**Technical TPP  
Field Change Notes**

**Updated 27th December 1994**

TPP Field Change Notice no. 80

Product ..... : DDE800 Wyse-370

Diagram 2

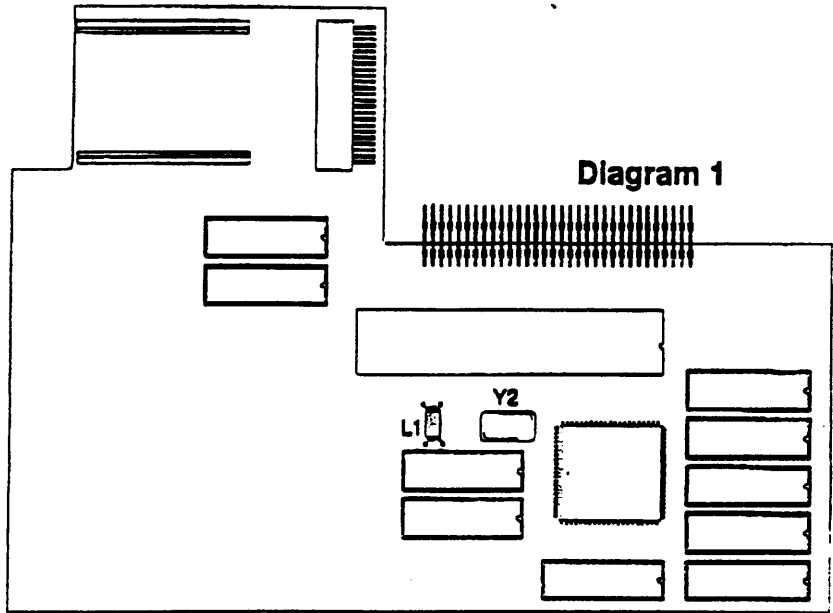
1. Remove the Logic PCB from the unit. Refer to the WY-370 Maintenance Manual Page 2-8 for the removal procedure.
2. Replace the 63.97056 MHz crystal oscillator (P/N 392000-30) at location Y2 on the Logic PCB with the new 64 MHz crystal oscillator (P/N 392000-31). Refer to Diagram 1 for location.
3. Remove ferrite bead L1. Refer to Diagram 1 for location.
4. Install the two jumpers to replace the ferrite bead. Refer to Diagram 2 for correct positioning.
5. Mark the PCB to reflect the change.
6. Re-assemble the unit.
7. Update the schematic and the parts list to reflect the change.

FIG. 5 MODIFIED -VERSION  
 (\* : NEW OR REPLACED COMPONENTS)

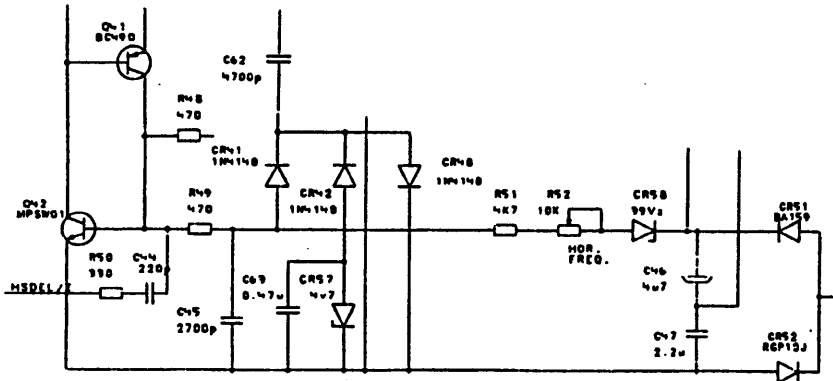
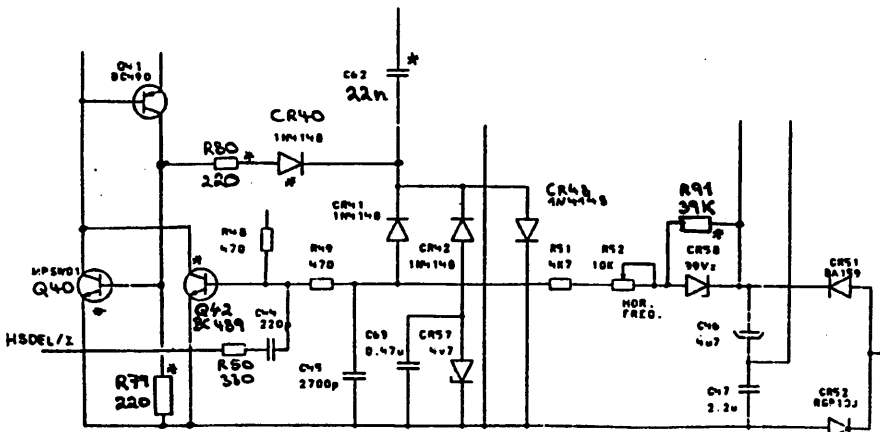
The modification of the Horizontal Oscillator circuit is as shown in Fig. 1 to 5. Fig. 3 shows the component side layer of the PCB, where a cut has been made as indicated. Fig. 2 shows the present state of the PCB layout. Fig. 4 and 5 shows the present and modified circuit diagram respectively.

FIG. 5 MODIFIED -VERSION  
(\* : NEW OR REPLACED COMPONENTS)

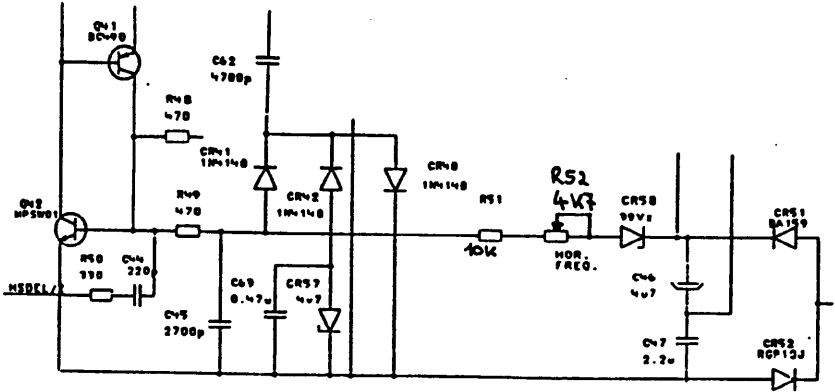
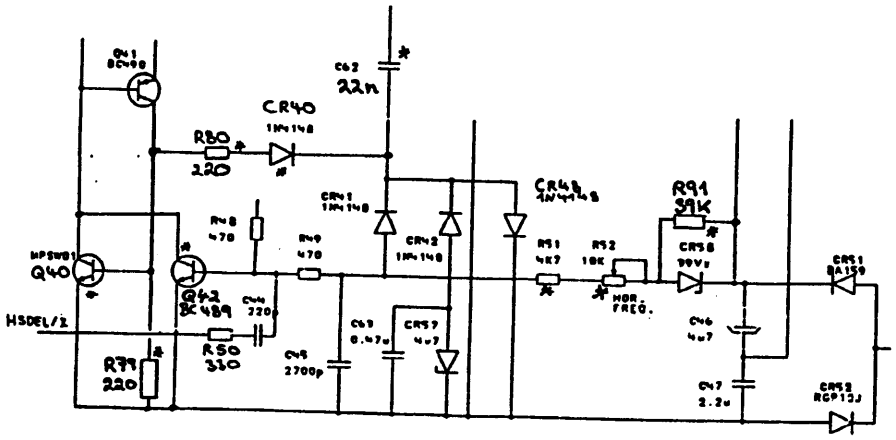
1) The Horizontal Oscillator circuit is modified as shown in fig.1 to 5. This includes the new (or replaced) components.

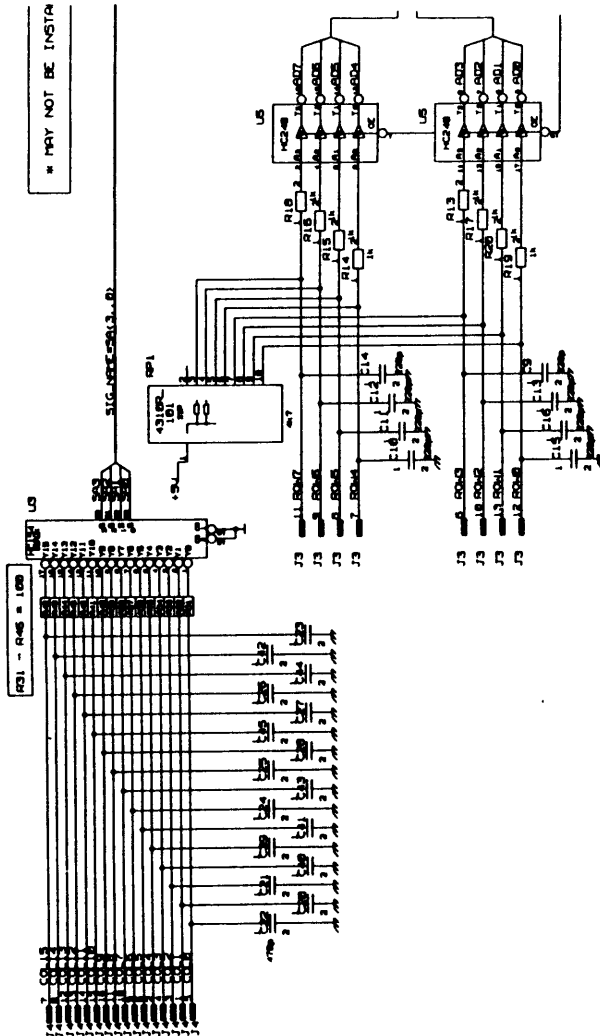
We have increased the ESD immunity for the keyboard.

The product had an ESD immunity of 15 KV. This has now been increased to 20 KV, as we have connected capacitors and resistors to connectors J3 and J4. See the enclosed schematics. A new PCB-layout has been made to implement this modification.

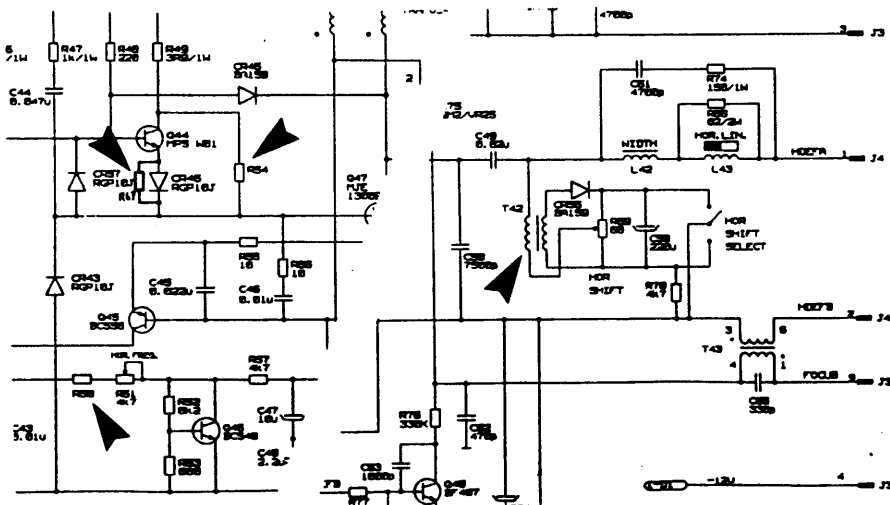
The values of R54 and R67 are made selectable.

R54 has default value 220 Ω, 1/4 W; part no. 39 51 14  
R67 has default value 8.2 Ω; part no. 39 22 19

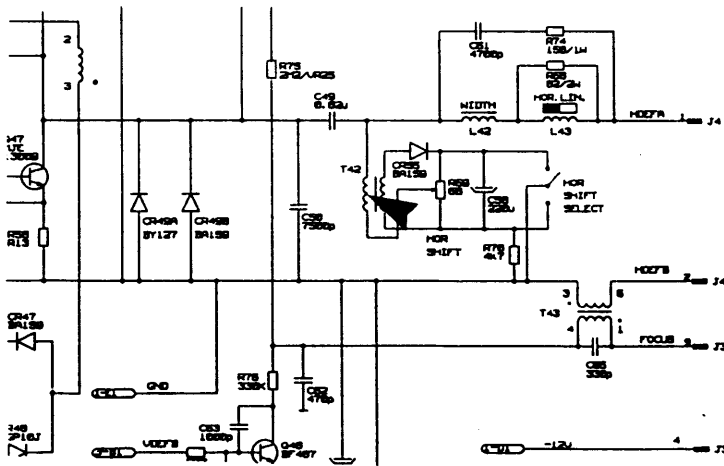
Refer to ECN-12/189, Power/Deflection level 17.5

To ease the production process, the horizontal shift area is increased. This is done by changing to a new horizontal shift transformer (T42).

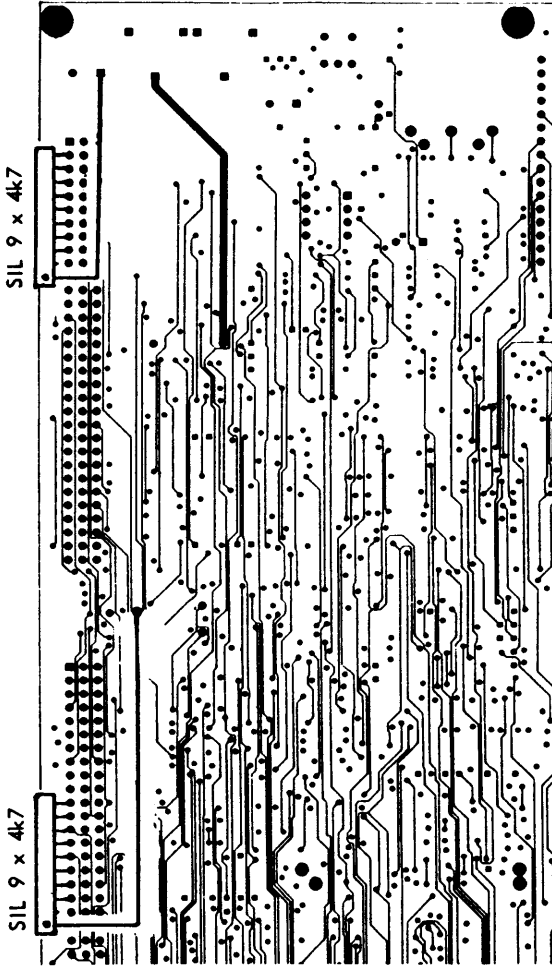
**Reason for change**  
 During the bootphase of OS/2 the computer may go down. It incorrectly detects memory on the AT-bus, tries to use it, and breaks down.

**Description of change**  
 Pull up the AT-bus SD datapath using two 9\*4k7 SIL's placed on the solder side of the PCB as shown on the following pages.

NO: 23-095

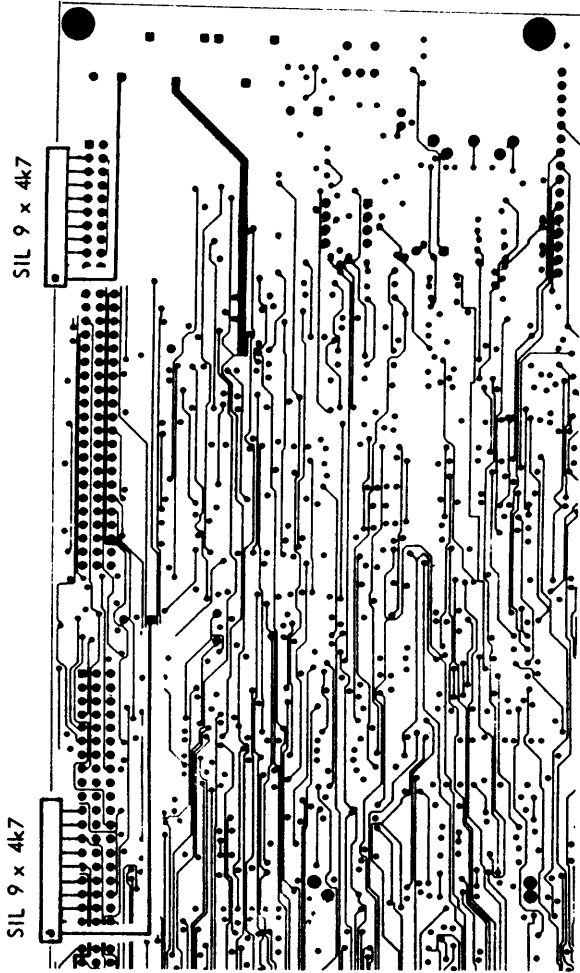
CPU453: Two 9\*4k7 SIL's placed on the solder side of the PCB 2214950A.

Figure 1

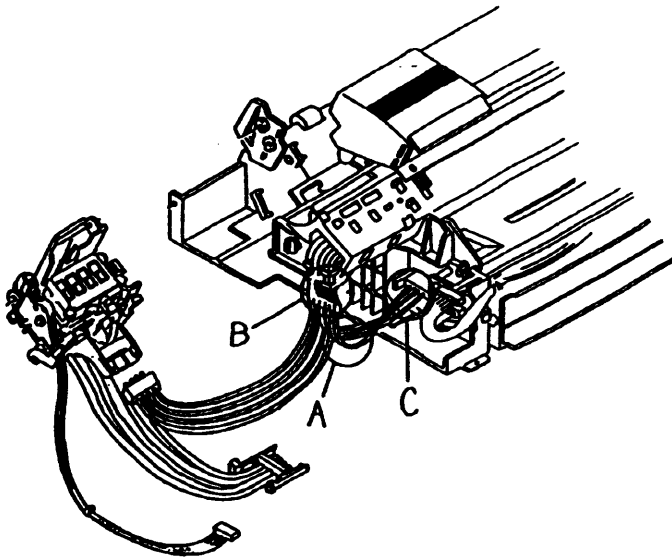
When the upper cover is installed, there is a possibility that the ink supply tubes (A in Figure 1) of the carriage unit may be caught in the upper cover. To prevent this, a guide was added to the left frame plate of the carriage frame unit (B in Figure 1). However, it has been found that when the joint holder is attached to the hook on the left of the carriage frame in servicing, stress may be applied between the supply joint and the ink supply tubes (C in Figure 1). In such a case, there is a possibility that the ink supply tubes may come off or loose the supply joint. To prevent this, be careful for the following.

Fig. 2: View B (fig. 1)

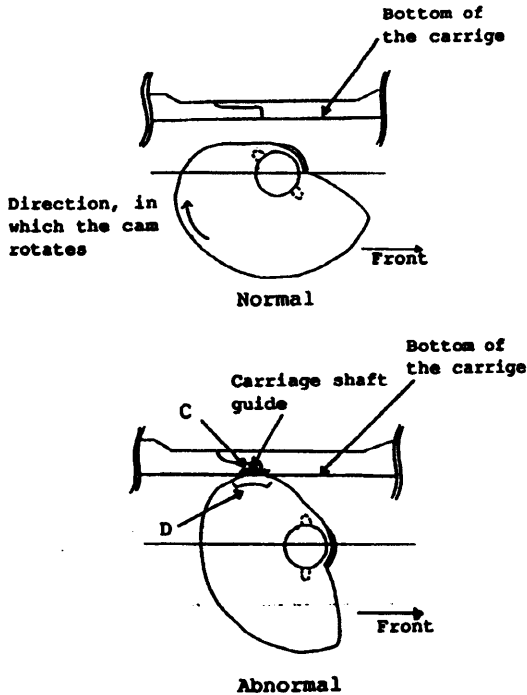
When the printer is powered OFF during the paper pick-up operation, the cam stops rotating at the abnormal position. In such a case, when the printer is powered ON again, the carriage (C in figure 2) hits the cam (D in figure 2) during initialization, causing the "5E SERVICE" error. This occurs only when the above abnormal operation is done in the printer with the modified cam (QB1-0024-020), whose outer round part was thickened.

Figure 1

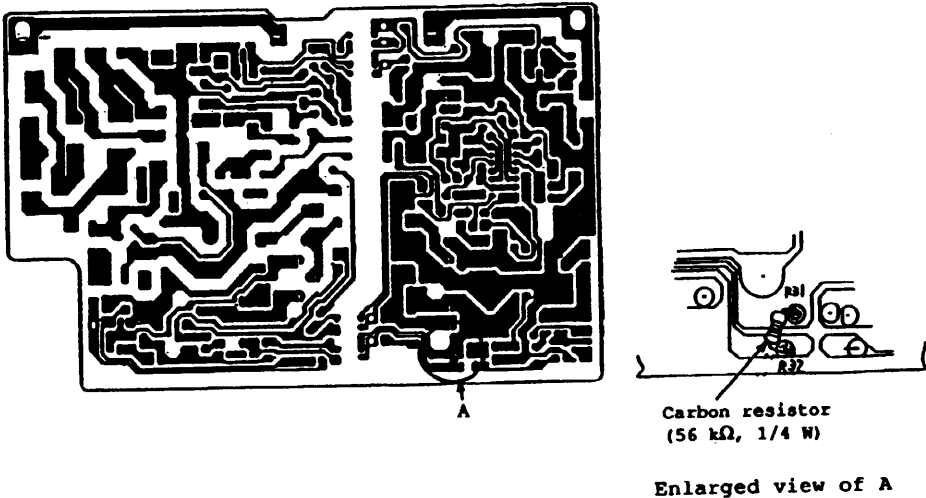
Note: As a temporary countermeasure, a carbon resistor (56 k $\Omega$ , 1/4 W) is soldered on the P.C. Board (figure 1).

Figure 1

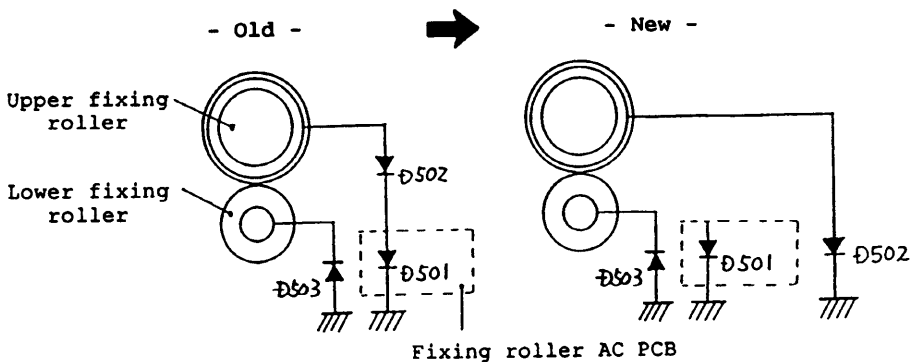
The location of D502 has been changed.  
Along with this change, the grounding method of the upper fixing roller has been changed. Refer to figures 1, 2 and 3.

**Figure 1**

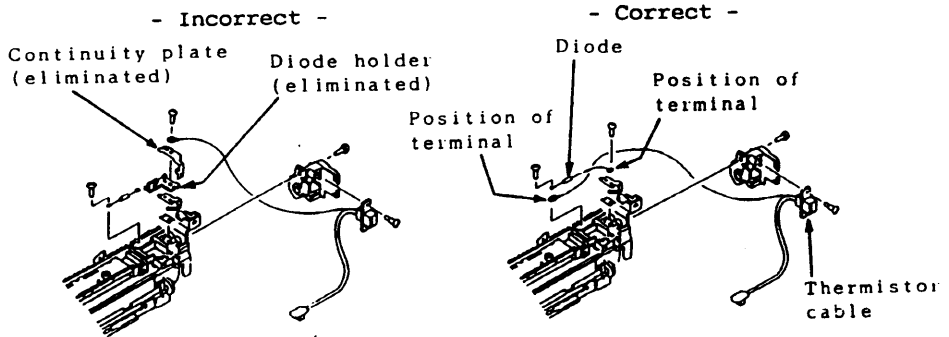
Please correct the errors in Figure 810 (Fixing Assembly) of the Parts Catalogue for models LBP-4 PLUS & LBP-4 LITE as shown in figure 1.

**Fig.1: Cover**

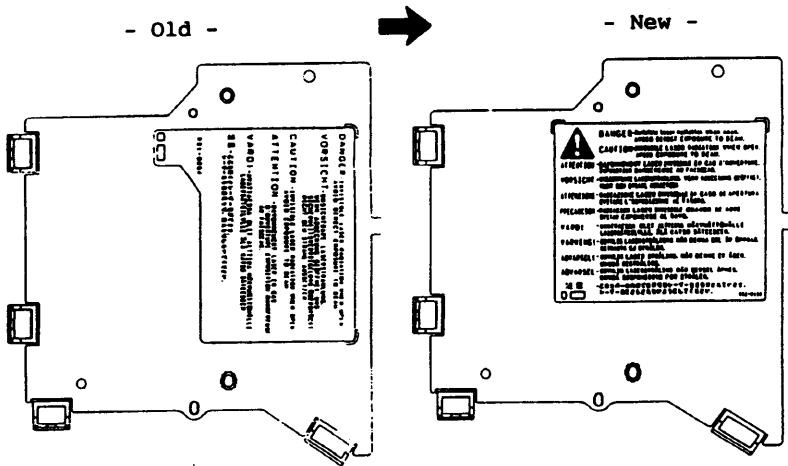
To comply with the safety standard of laser, the laser warning label has been modified (figure 1):

- 1) The warning, written in six languages before, is now written in ten languages.
- 2) The warning sign has been added.
- 3) The shape of the label has been changed. Along with this, the position of the rib on the cover has also been changed.

**Figure 1**

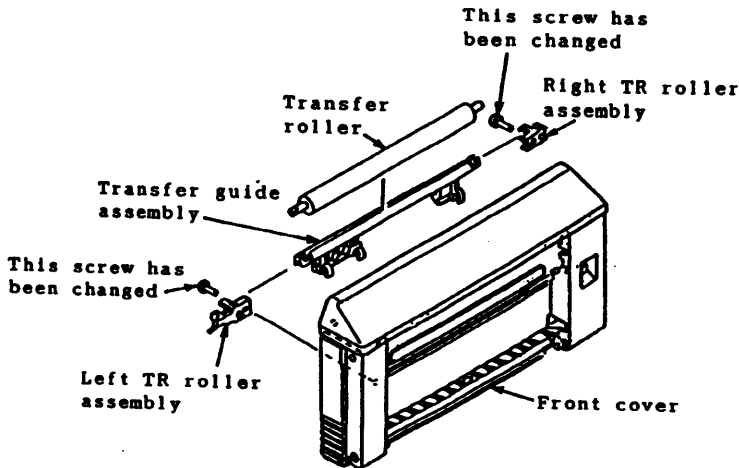
The screws fixing the right and left TR Roller Mount Assemblies have been changed. Refer to figure 1.

**Figure 1**

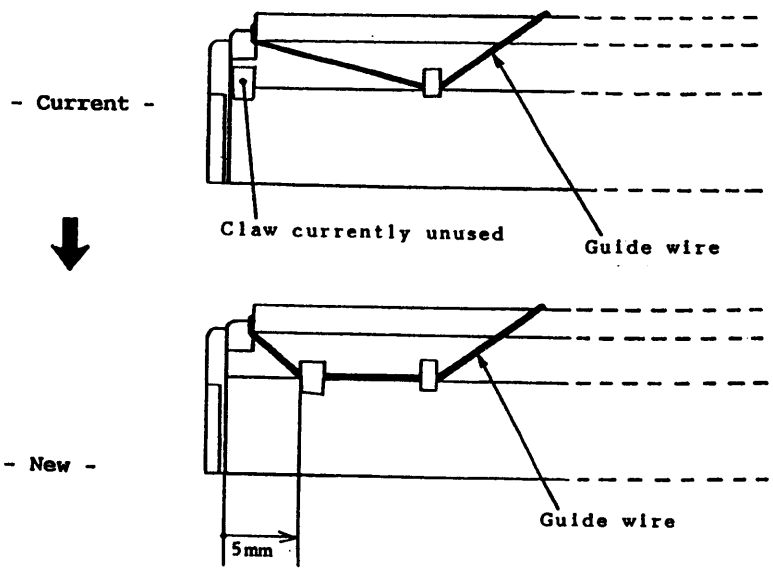
To prevent the guide wire from coming off the claw on the static charge eliminator, unused claws at both ends are now also used as shown in figure 1.

Figure 1

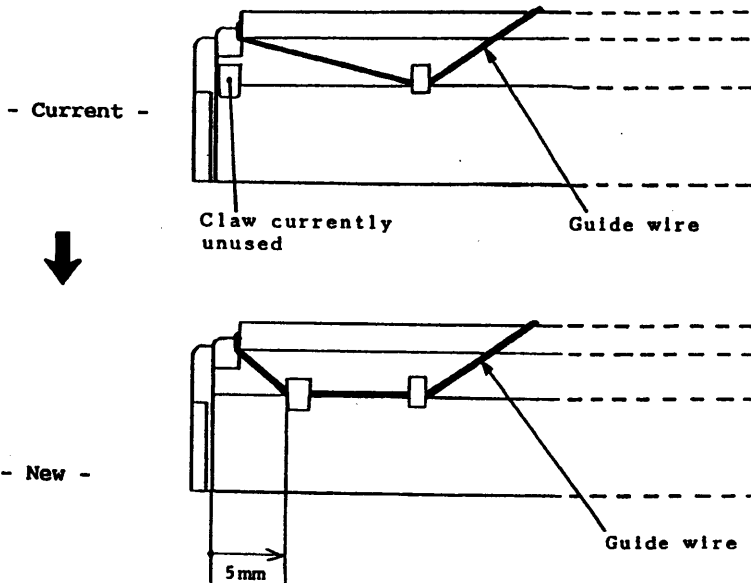
To prevent the guide wire from coming off the claw on the static charge eliminator, unused claws at both ends are now also used as shown in figure 1.

**Fig. 1: Interface P.C.B. Assembly**

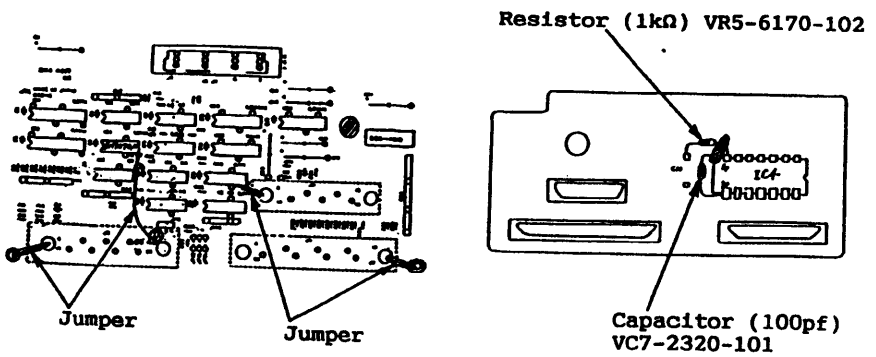
To increase the margin for electrostatic discharge, IC4 and R10 on the Interface P.C.B. Assembly have been changed. Along with this change, jumpers, a resistor (1k $\Omega$ ) and a capacitor (100pF) have been added. Refer to figure 1.

**Figure 1**

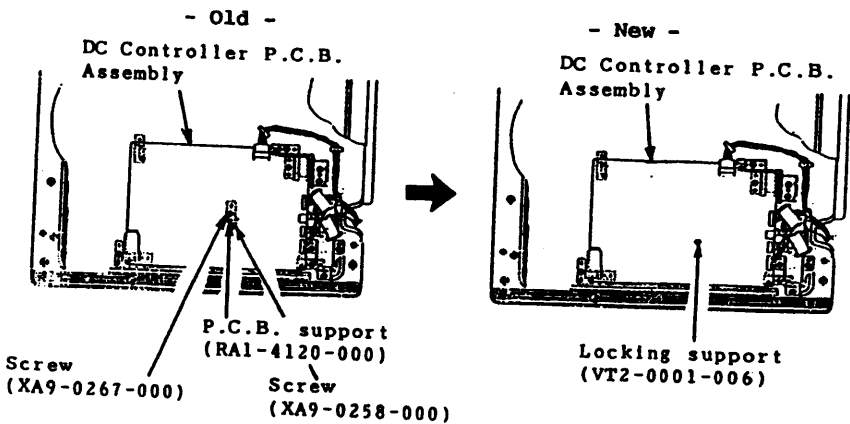
The following modifications have also been made (figure 1):

1. The diameter of the hole in the DC Controller P.C.B. Assembly has been changed from 4.5mm to 4.0mm.
2. An additional hole (4.8mm) is made in the bottom plate.
3. Two screws have been eliminated.

**Figure 1**

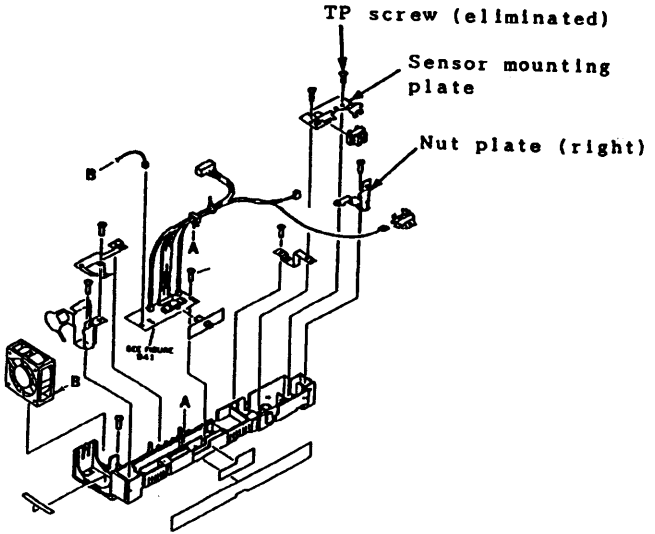
The sensor mounting plate and right nut plate (figure 1) have been combined. Along with this change, a TP screw has been eliminated.

**Figure 1**

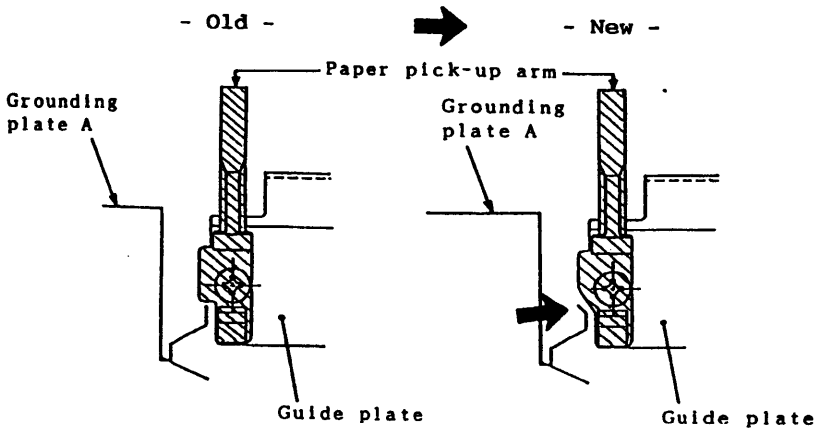
To prevent this, the paper pick-up arm and grounding plate A have been modified. Refer to figure 1.

**Fig. 1: Fixing Assembly**

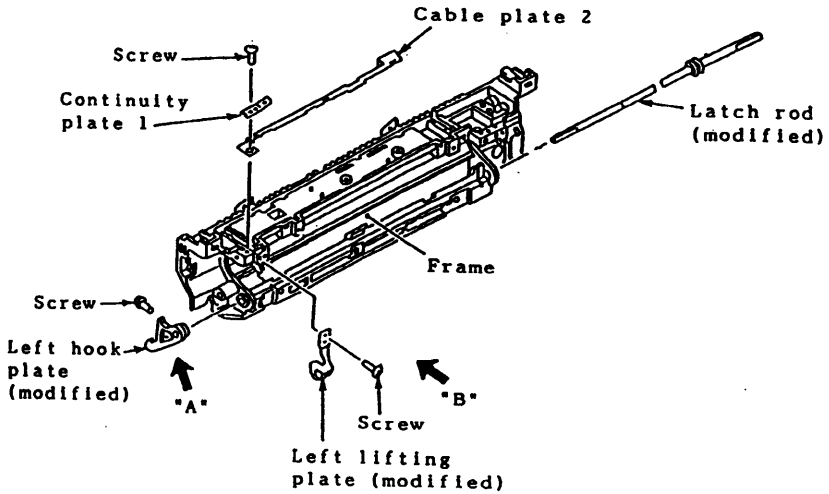
The positions of the screws fixing the left hook plate and left lifting plate have been changed, in order to increase the distance between these screws and the AC line of the halogen heater. For further details, refer to figures 1, 2 and 3.
